PCI-SIG ENGINEERING CHANGE NOTICE

TITLE:	Mini Card Thermal Guidelines Changes
DATE:	October 28, 2005
AFFECTED DOCUMENT:	PCIe Mini CEM Specification, Revision 1.1
SPONSOR:	Jim Panian, QUALCOMM

Change Section 2.4 on page 23:

Figure 6-1: Power Density Uniform Loading at 80 Percent Coverage

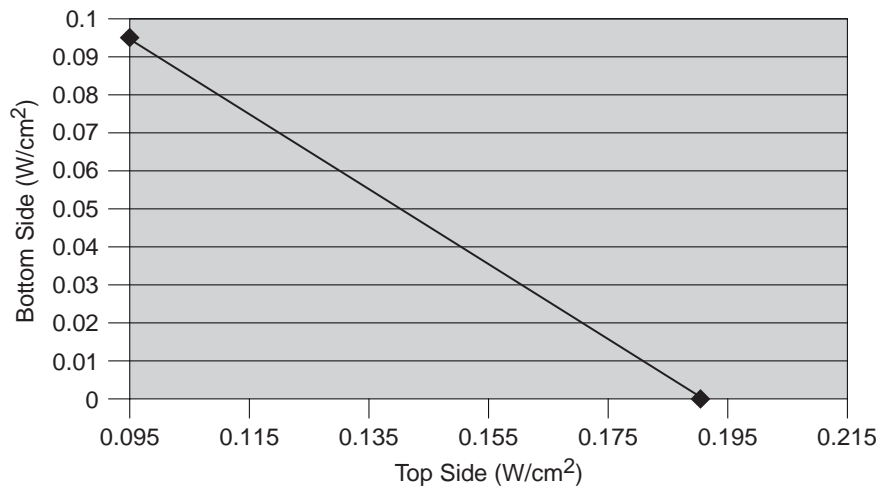
Example: If side one of the card is loaded to 0.12 W/cm², the other side of the card (side two) can only be loaded to 0.07 W/cm². In all cases, the sum of power densities for both sides of the card should not exceed 0.19 W/cm².

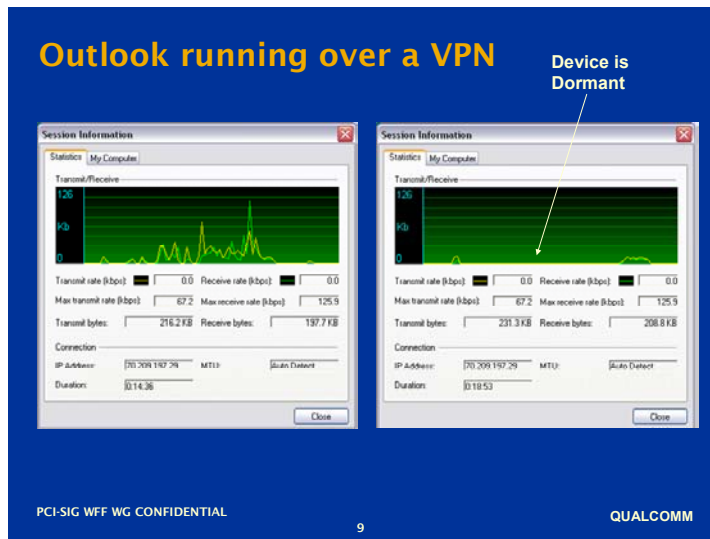
- The WWAN add-in card typically does not operate in the worst-case operating mode. For example, consider CDMA 2000 1xEVDO. The Maximum Thermal Dissipation varies based upon the distance from the base station:

- Max Thermal Dissipation = 1.0 W (close to the base station)
 - Max Thermal Dissipation = 1.8 W (middle of the cell)
 - Max Thermal Dissipation = 2.7 W (edge of the cell)

These values are representative. Max input voltage is assumed.

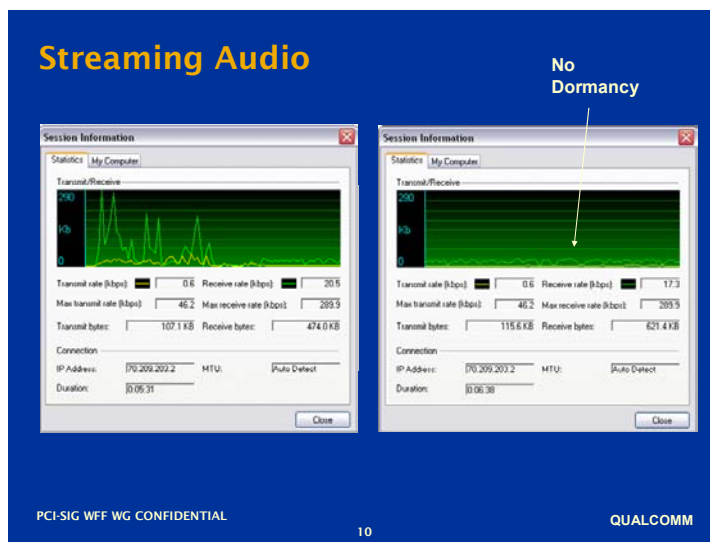
- Average Thermal Dissipation: $\ll 1$ W
- Maximum Thermal Dissipation: < 1 W
- The Average Thermal Dissipation is function of the user-level application that is running and the distance from the base station. Most business applications enable the device to go dormant thereby lowering the average thermal dissipation
 - Average Thermal Dissipation $<$ Max Thermal Dissipation

- Applications that perform data streaming such as VOIP, video streaming from an attached camera or streaming audio prevent the device from going dormant
 - Average Thermal Dissipation = Max Thermal Dissipation
